Board of County Commissioners • Escambia County, Florida

ADDENDUM NUMBER 1:

Re: PD 17-18.067 Pensacola Beach Sign Frame Replacement

3 EAST ELEVATION
S-4 1/4" = 1'-0"

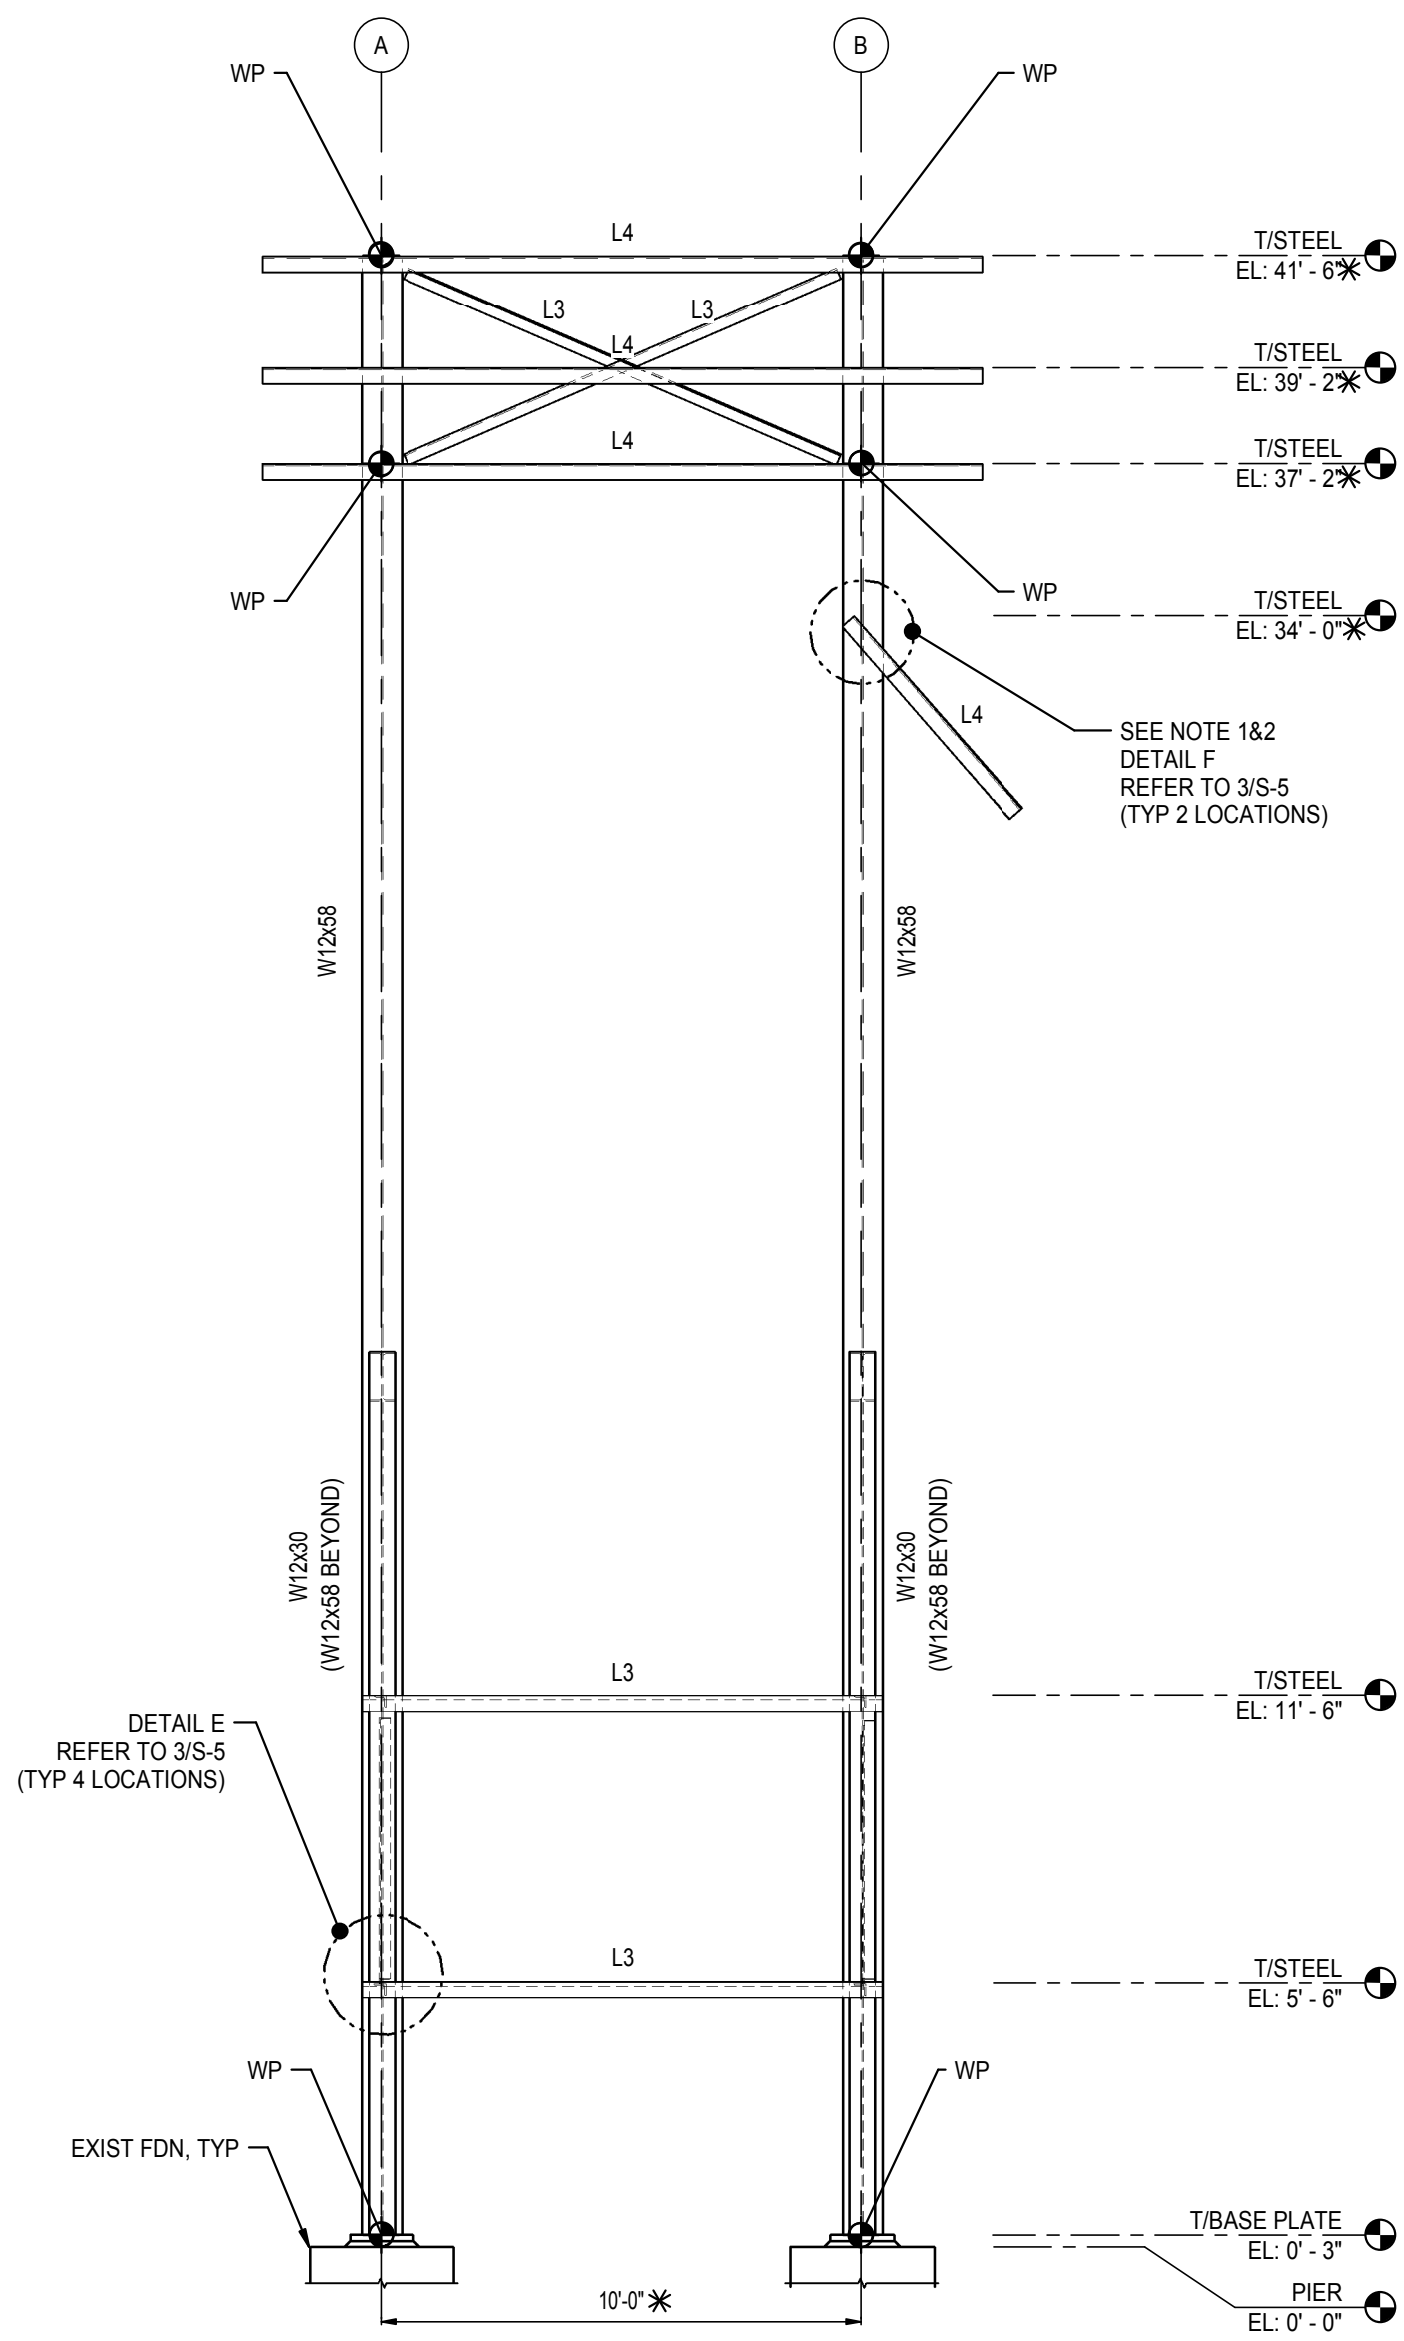
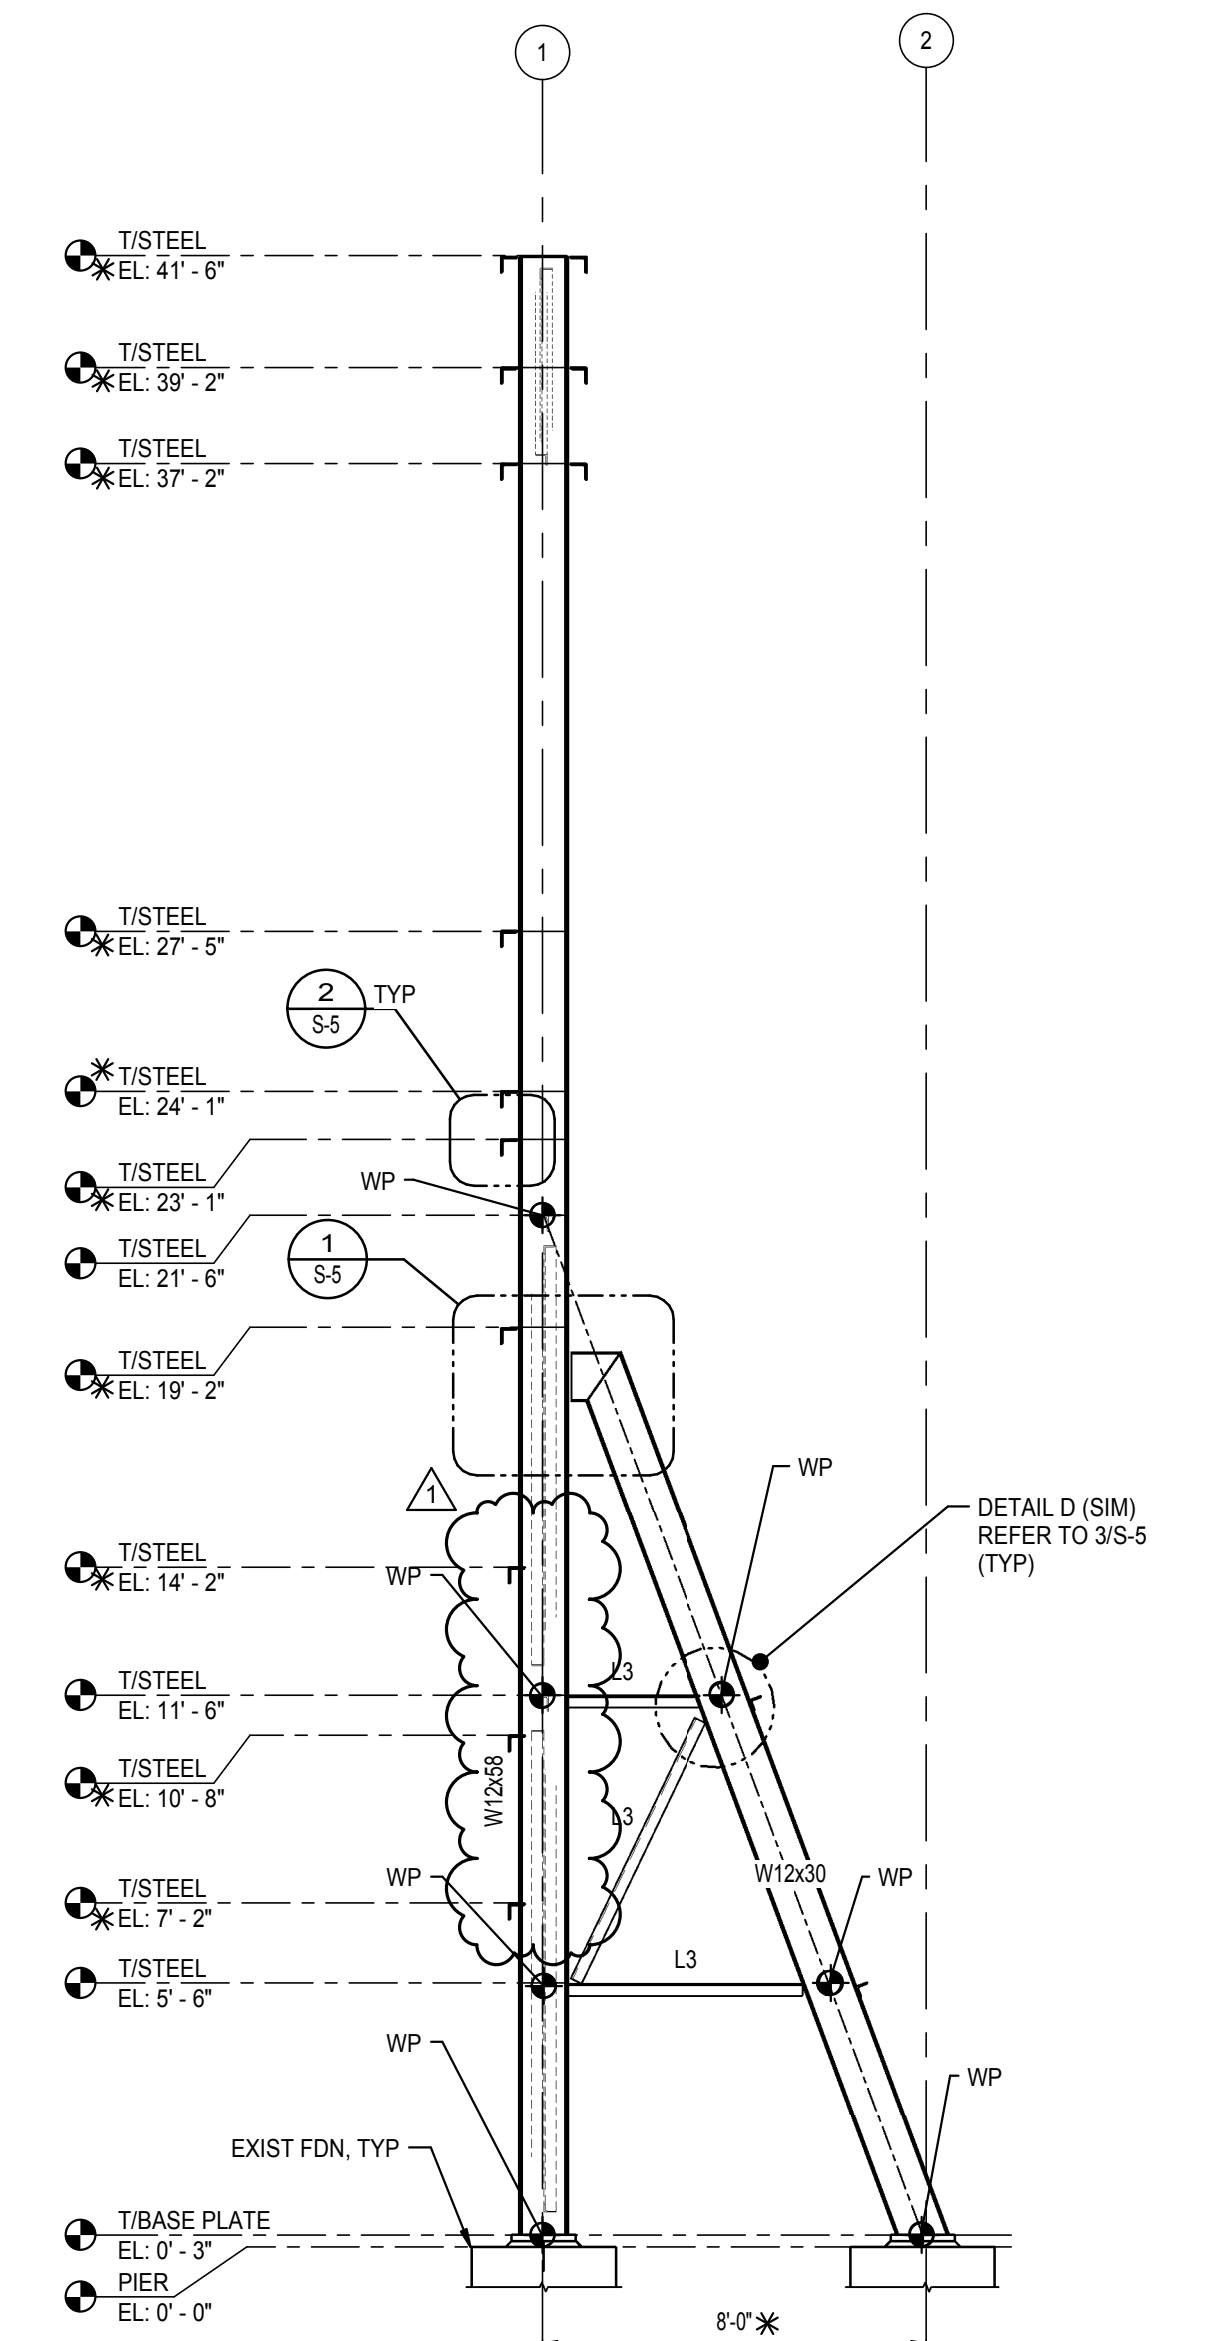
1. Refer to the attached drawing S-4 for framing revision at bottom sign. Provide (3) L4x4x3/8 angles for bottom sign. Elevations and length shall be coordinated with new bottom sign and field measurements. Connections to match those proposed for middle and top signs and as shown on 2/S-5.
